Australian Air Publication 721.79

**Volume 2, Part 2
Book 3**

VAMPIRE MODIFICATIONS

(Nos 201 to 300)

DE HAVILLAND DRWG. No. 00M 360. No of SHTS. 5 SHT. No. 1

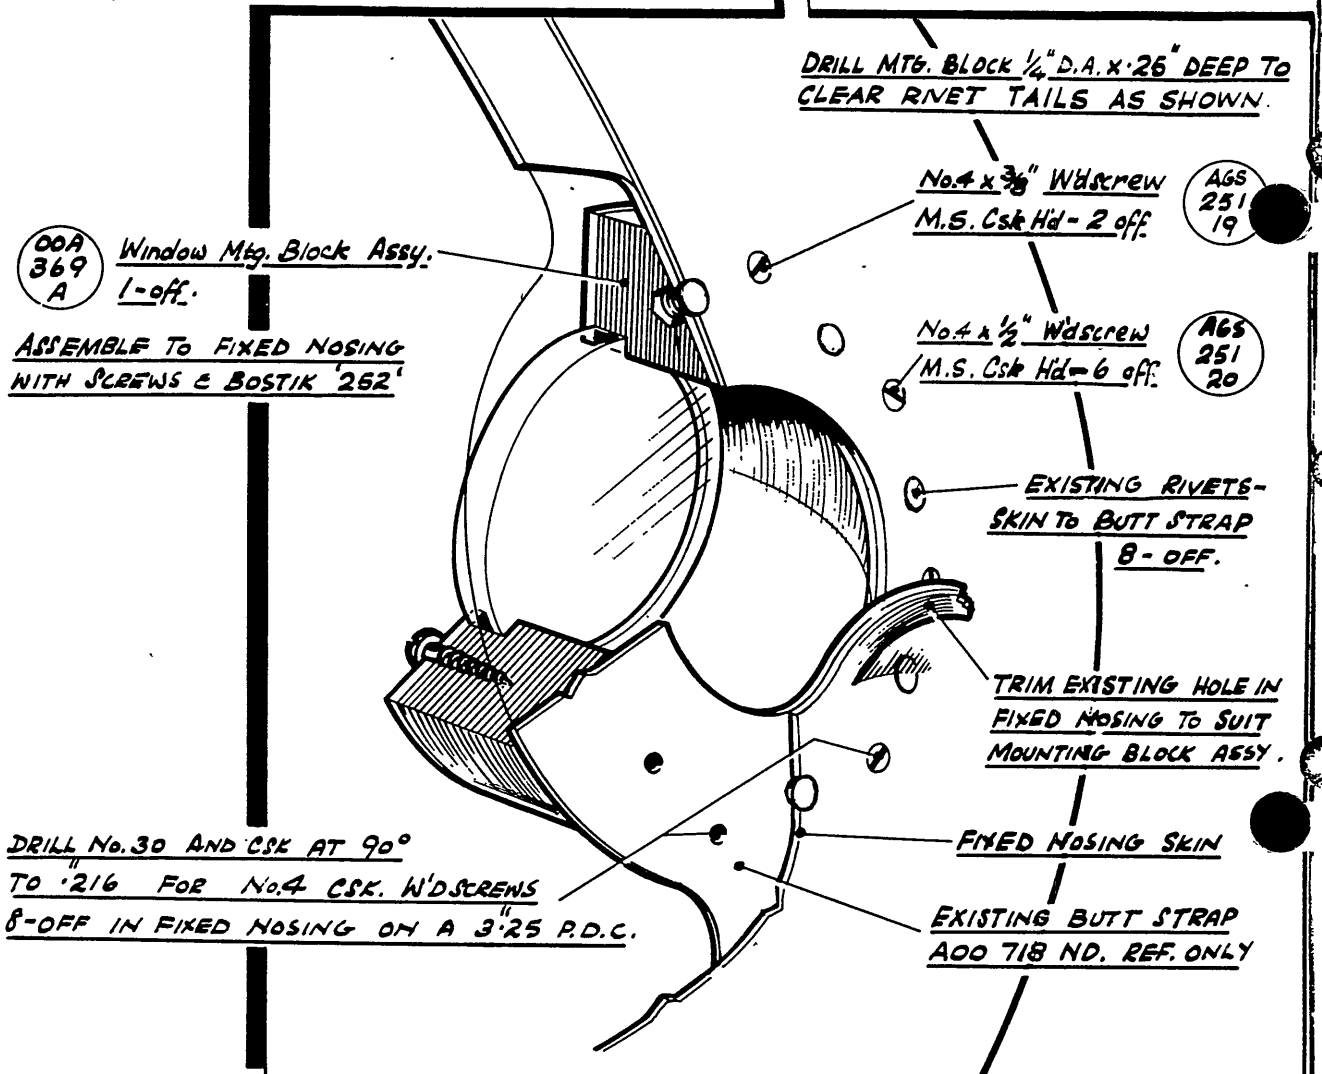
- (xv) Working now on the Fixed nosing DH
Part No A00717A/5 Ref locate the Camera
Aperture and remove and discard if fitted,
the cover plates, item 21, and its attaching
bolt. Attach the window mounting assembly,
item 2, to the fixed nosing as per sheet 1
of DH drawing A12982 using items 6 and 7.

DE HAVILLAND DWG No. 00M-360
SHEET 3 OF 5

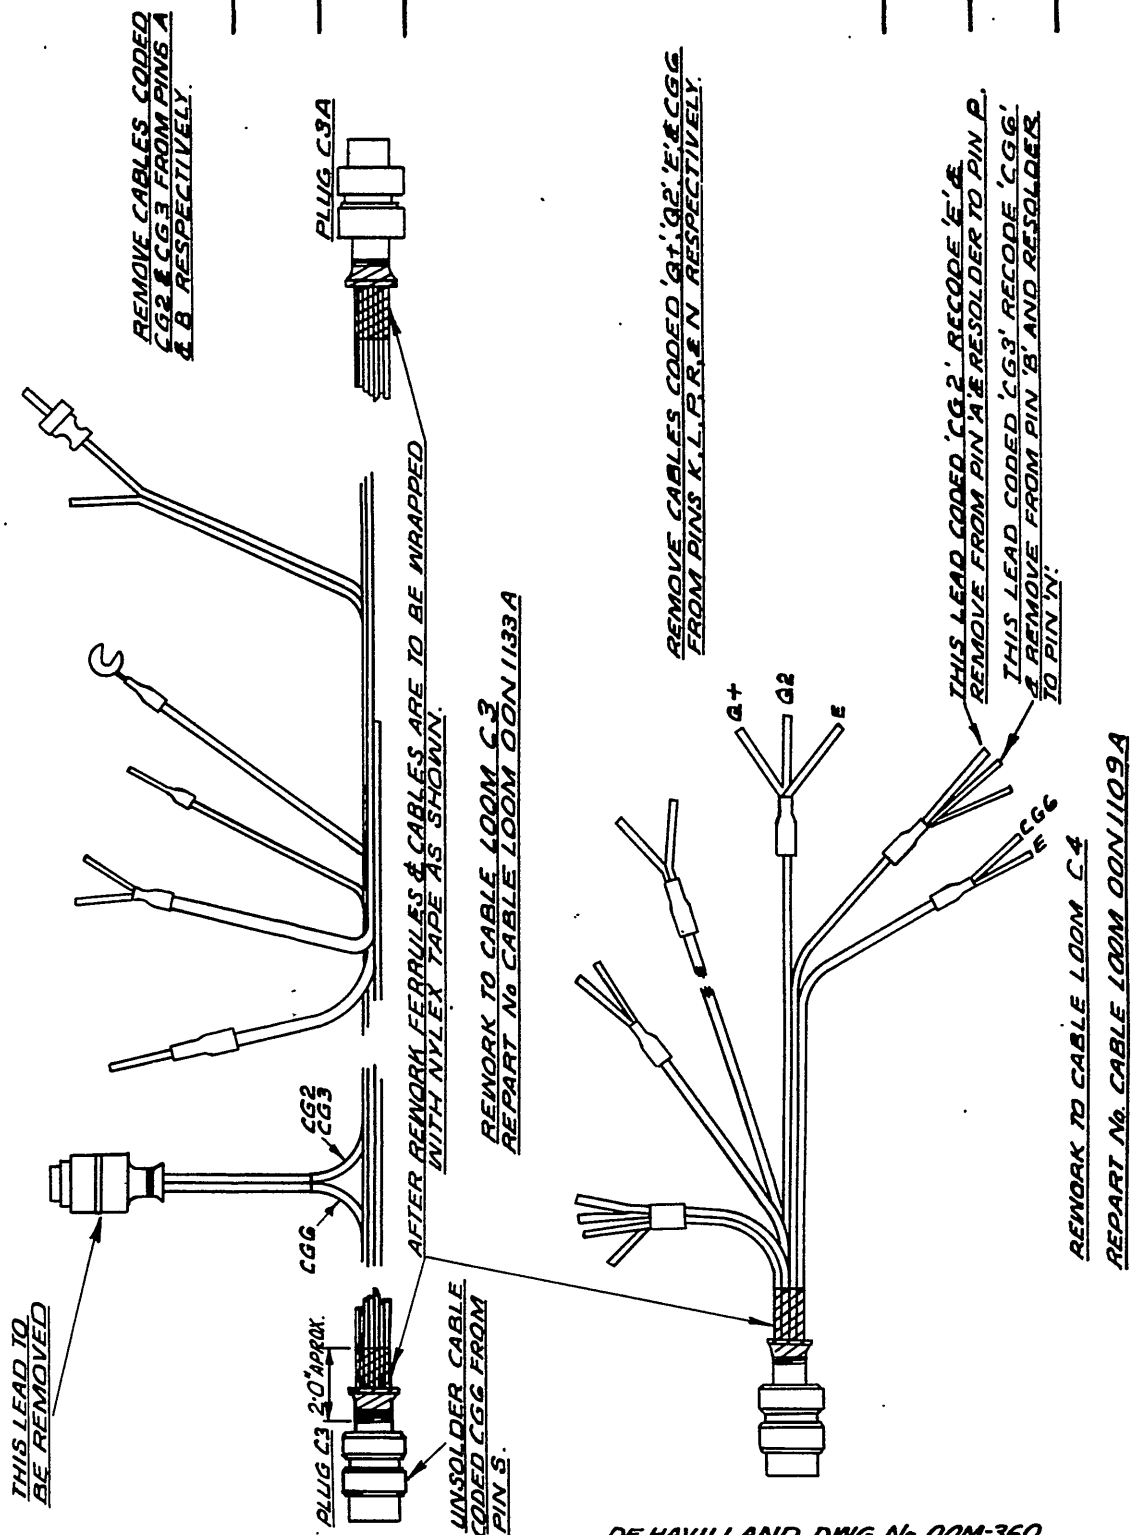
- (xi) This loom is to be reworked as shown on sheet 3 of Drawing A12982 using items 12, 14, 15 and 16, after rework repart No this Loom Assy OON1109A and reinstall in its former position in the aircraft.
- (xii) Now locate and remove the cable loom assembly C3 Part No OON1007A Ref, which is attached to the aft face of bulkhead No 1 and runs to a breeze plug in Junction Box No 1. This loom is to be reworked as shown on sheet 3 of Drawing A12982 using items 12, 14, 15 and 16. After rework repart No this Loom OON1133A and reinstall in its former position in the aircraft.
- (xiii) NOTE: This paragraph is applicable to Mk 31 aircraft only.

DE HAVILLAND DWG. No. 00M 360 SHEET 4 OF 5

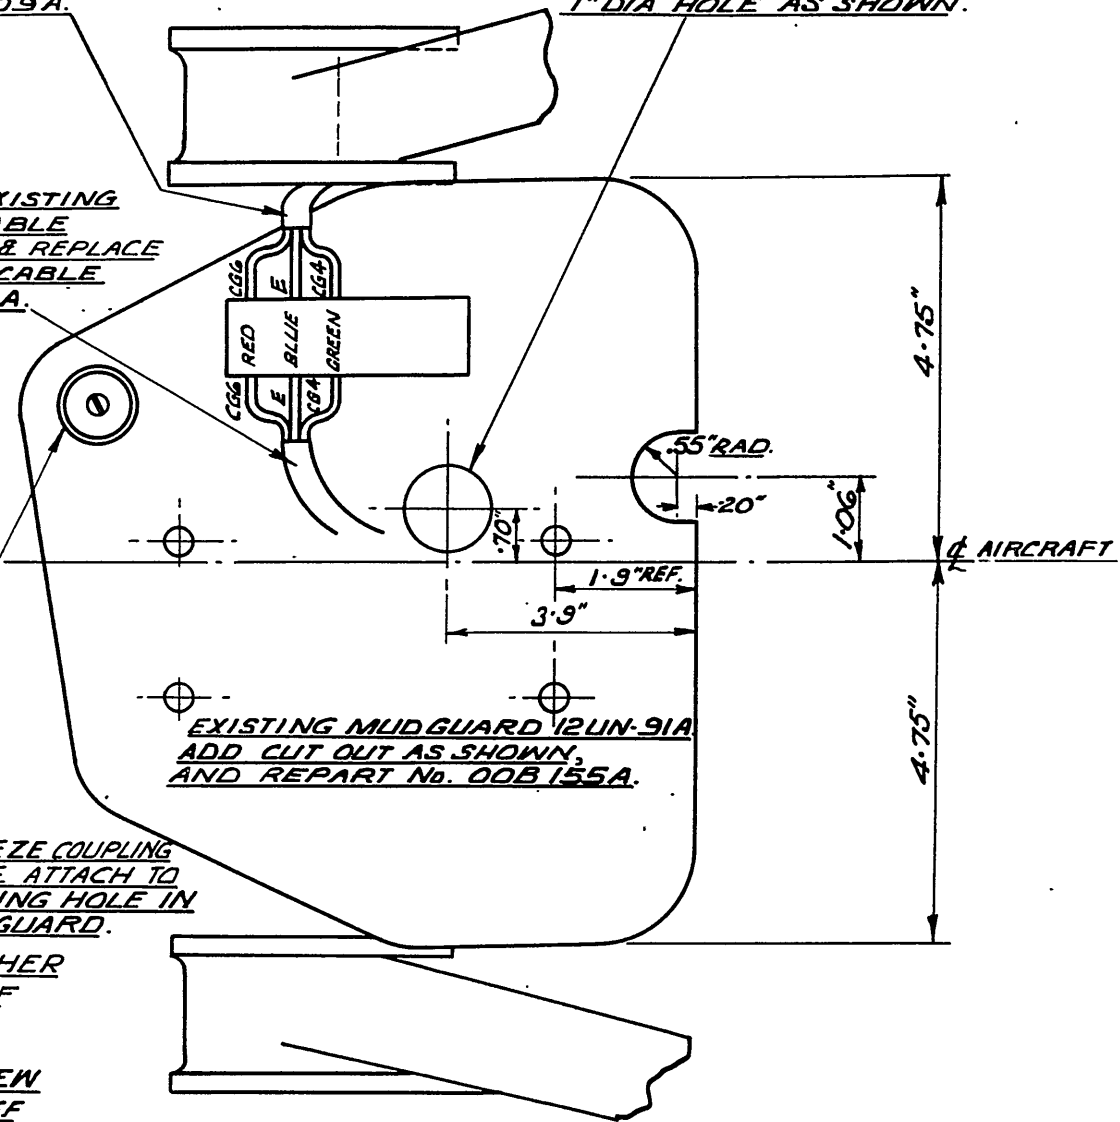
- (v) On the mud guard it will be necessary to make the small cut out shown on sheet 4 drawing A12982.
- (vi) The Cable Assy, item 20, which runs from the terminal block to the camera is to be completely removed from the aircraft and discarded. The socket, item 26, if serviceable, may be salvaged from this cable.

- (vii) Replace this cable by a new cable, item 1, connecting the three ends to their respective terminals CG6, CG4 and E. Refer to sheet 4 of drawing A12982.

REMOVE EXISTING
CAMERA CABLE
NOD-272A & REPLACE
WITH NEW CABLE
00N-1107A.

DE HAVILLAND DRAWING NO. DDM349 SHEET 2 OF 3 SHEETS.

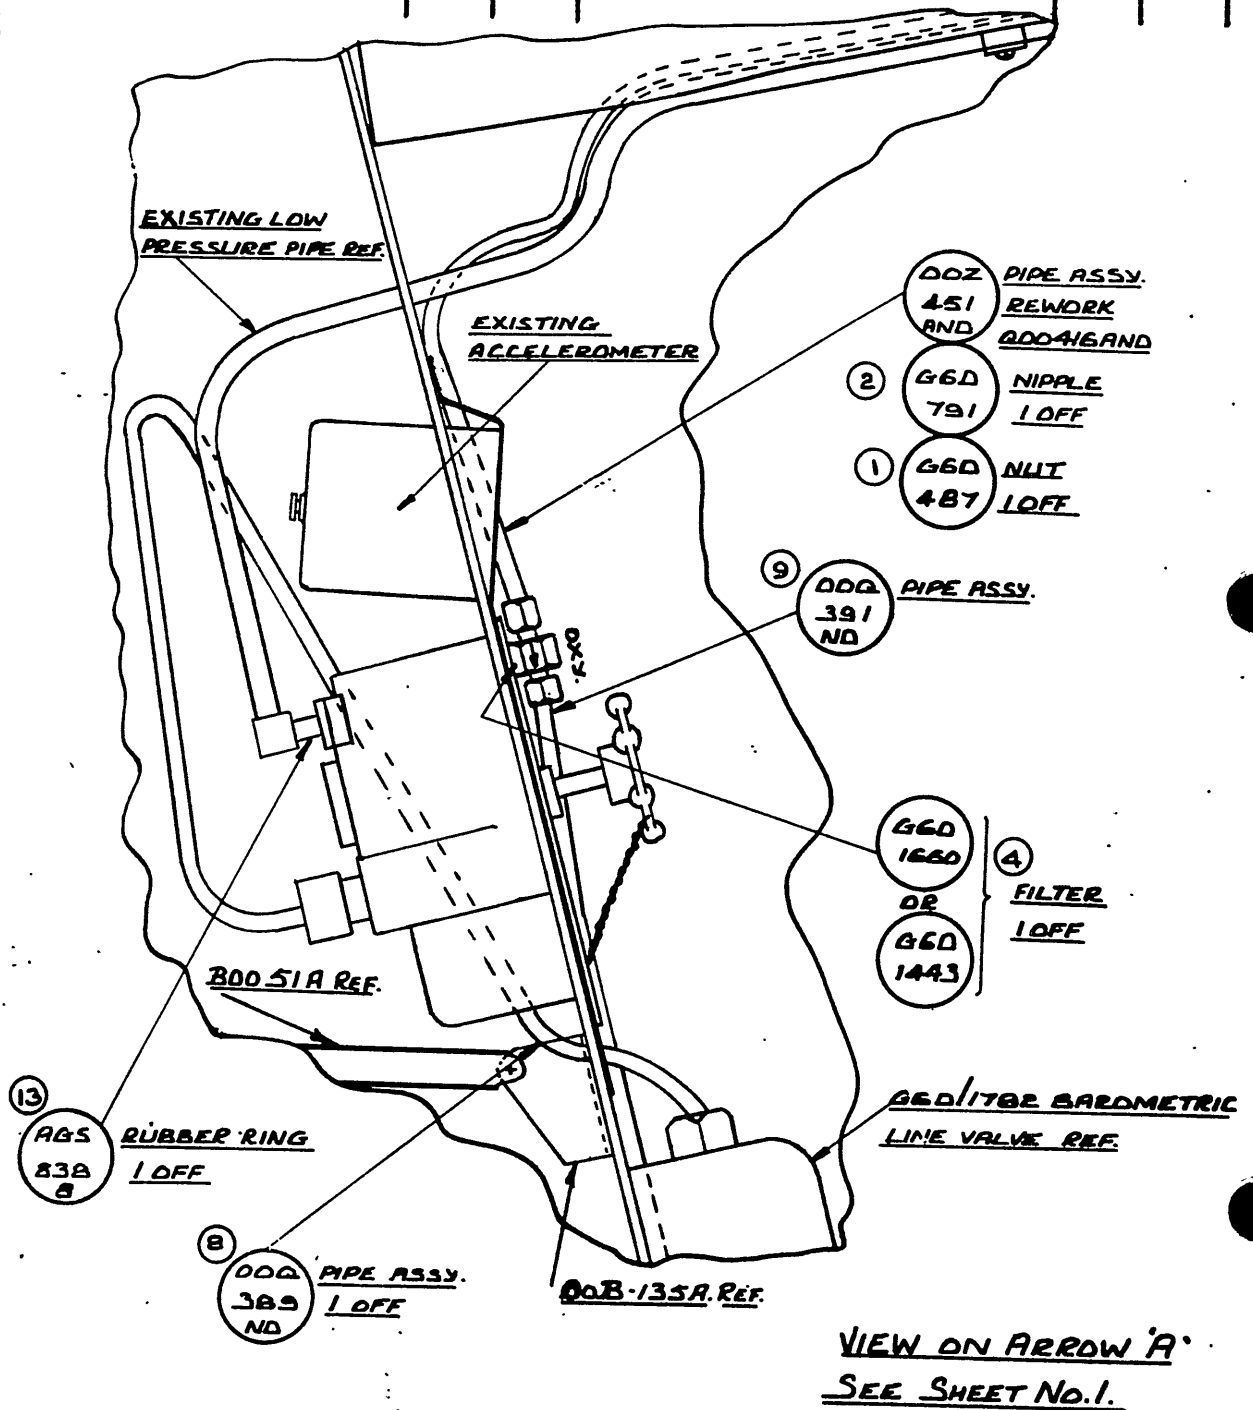
- (xxviii) Reconnect the existing low pressure pipe (disconnected in operation (iv)) to the regulator after replacing the existing rubber ring with new rubber ring (Item 13) 1 off. See drawing A12882 sheet No 2.
